# Planning Referral

**To:** Amy Hodgen  
**From:** Julian Wearne  
**Date:** 12/04/2016  
**Subject:** Strategic Transport Comments  
**Application No:** PLN17/0703  
**Description:** Stage 2B of the Alphington Paper Mills Development. This stage of development which relates to Village Precinct (immediately east of the Caydon site).  
**Site Address** AMCOR Stage 2B - 626 Heidelberg Road, Alphington

*Figure 1: These lines appear to indicate physical barriers, however this would preclude vehicle access to AMCOR Stage 2A. Notations should be added or otherwise indicated to clarify the purpose of these markings.*

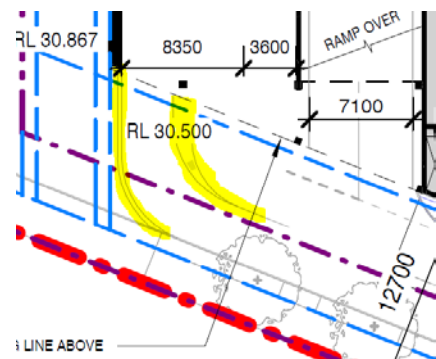
The plans do not clearly show continuation of the laneway to the south, which is understood to provide vehicle access to the development at AMCOR Stage 2A. All relevant floor plans should clearly indicate vehicle access continues past the western boundary of the subject site.

Further to the above, clarity regarding the nature of the highlighted sections in Figure 1 is required. These appear to be splitter islands or physical dividers; however given access to AMCOR Stage 2A is required, it would appear only line-marking is possible in these locations.

Figure 2 – The location of the bike ramp results in multiple opportunities for conflict with cars using the two adjacent ramps.

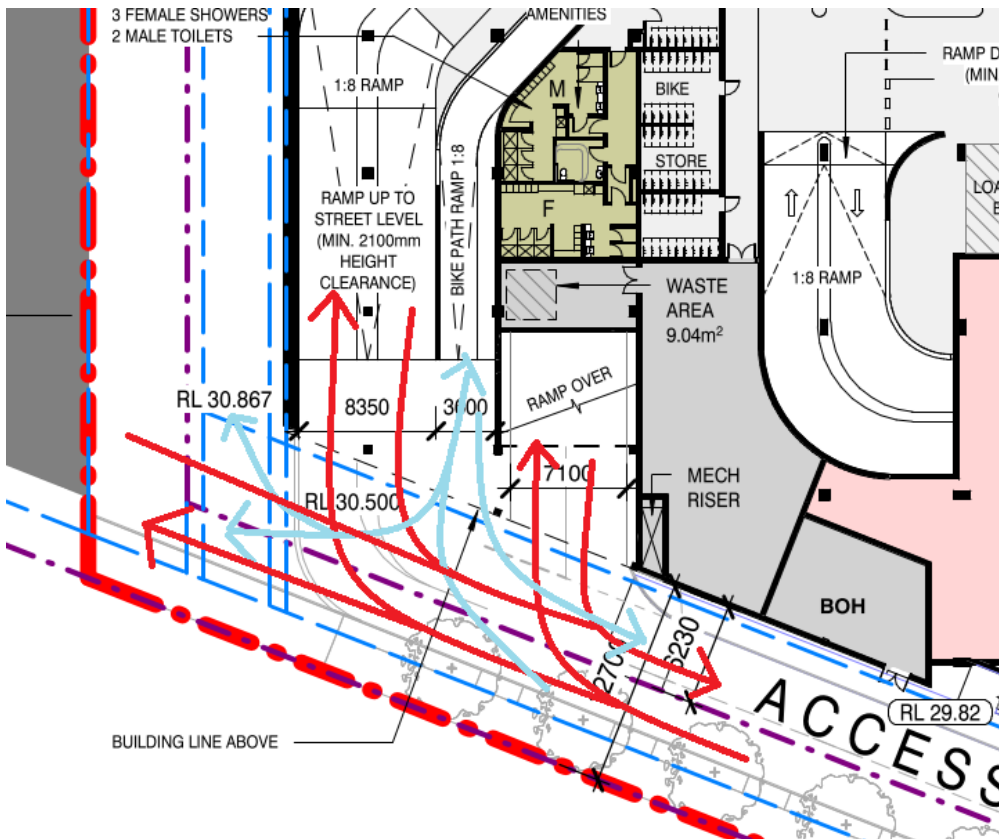
The location of the bicycle ramp to the lower-ground floor (LGF) car and bicycle parking area is of concern. The ramp is located immediately adjacent the car ramp to the LGF, and the car ramp up to the Level 1 car park. Given the location of the ramp, as cyclists enter or exit the ramp, there is potential conflict with cars in multiple directions (Figure 2.) Given the multiple opportunities for conflict, cyclists would need to be aware of movements in multiple directions, and for some of the movements, sightlines are likely to be problematic.

Further the ramp is at a 1:8 grade. Pursuant to Australian Standard AS2890.3, where possible ramps for cyclists should be at a 1:12 grade to provide easy access.

To address the above concerns it is recommended the cyclist ramp be relocated. One suggestion is to shift the ramp to the western side of the vehicle ramp to the LGF. This location would provide the following benefits:

- Cyclists heading into the LGF would not be required to cross the path of vehicles entering the LGF;
- Cyclists exiting the LGF to the west would only be required to interact with vehicles entering or exiting the development at Stage 2A;
- Cyclists exiting the LGF to the east would have sightlines of both vehicle ramps from a single vantage (rather than having one ramp behind them and one in-front);
- The ramp could more easily be lengthened, and therefore the gradient could be reduced to a grade closer to 1:12.

1. The bicycle entrance ramp to the lower-ground-floor car park redesigned or relocated to reduce conflict with motor vehicles accessing the lower ground-floor or first floor car park areas. The maximum grade of the bicycle ramp should also be reduced to 1:12 or to the satisfaction of the responsible authority.

Figure 3 – Walking distances between entrances (via lift) and the main resident bicycle storage facilities are excessive.

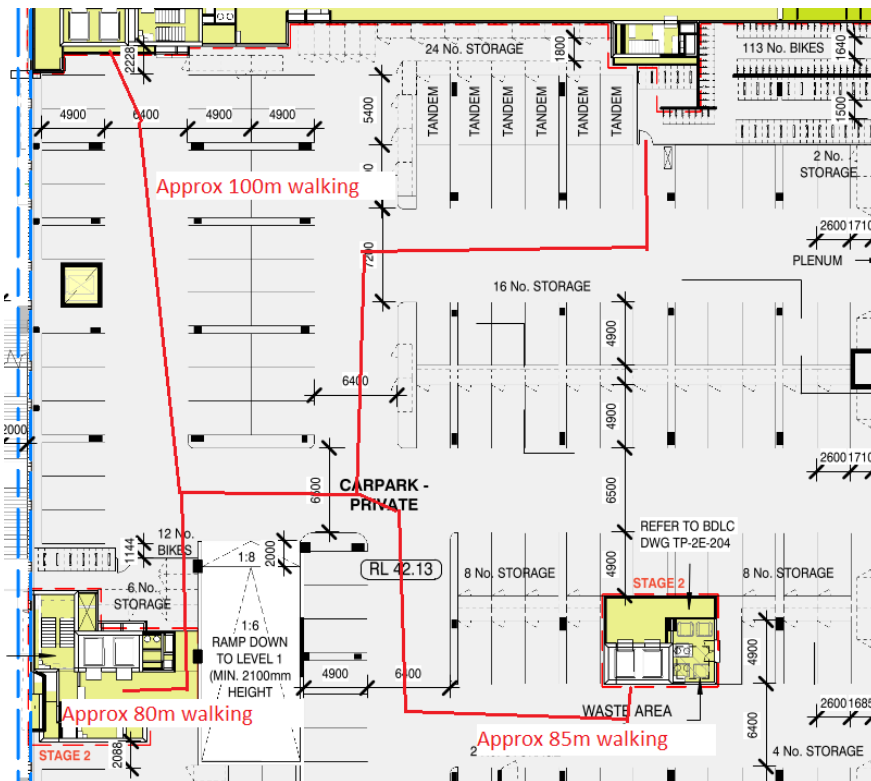
- These spaces are located approximately between 80-100m walking distance from each of the three lifts (Figure 3). This is well in excess of the 30m distance recommended by AS2890.3.

- These storage facilities should either be relocated to closer to the lifts, or more direct walking paths through the basement should be provided.
- The remaining spaces are located in close proximity to one of the lifts. These spaces are well located and are acceptable. It is noted one of the facilities includes 50 hanging spaces, and no horizontal spaces; but this is acceptable given approximately 38% of the (usable) resident spaces are provided as horizontal spaces, well in excess of the 20% required under AS2890.3.

This is in part due to indirect paths.

6. Walking distances from lifts to the residential bicycle storage facilities must be reduced. This can be achieved by relocating bicycle storage facilities, or providing more direct walking paths.

Figure 4 – A number of bicycle storage devices are shown located directly adjacent walls. These spaces would not be usable due to handlebar clearance.

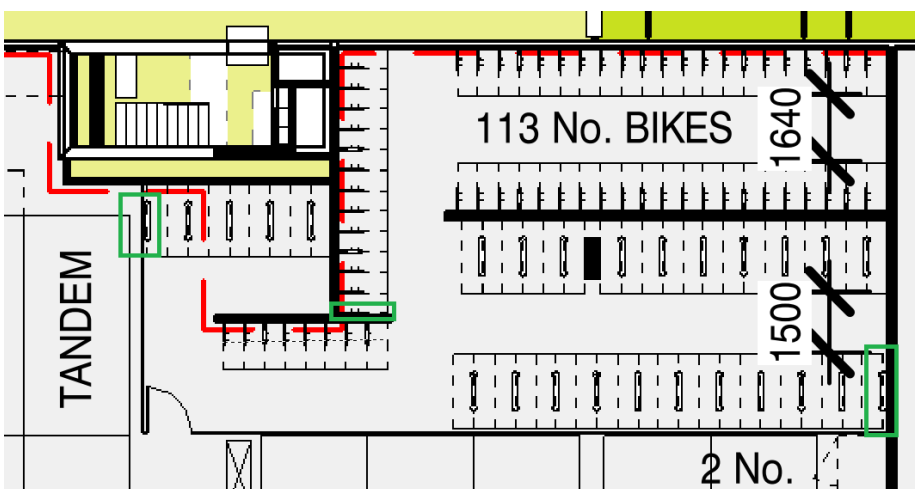
- 9 resident spaces do not appear to be usable, on account of directly abutting a wall (see Figure 4 for an example). All spaces must provide at least 500mm clearance for handlebars.

2. Real-time public transport information displays for nearby stops within major building lobbies.
3. Dimensions of bicycle storage spaces, and relevant access ways noted to demonstrate compliance with Australian Standard AS2890.3 or to the satisfaction of the Responsible Authority. Specifically, spaces must have a minimum 500mm clearance from walls to allow for handlebar clearance.
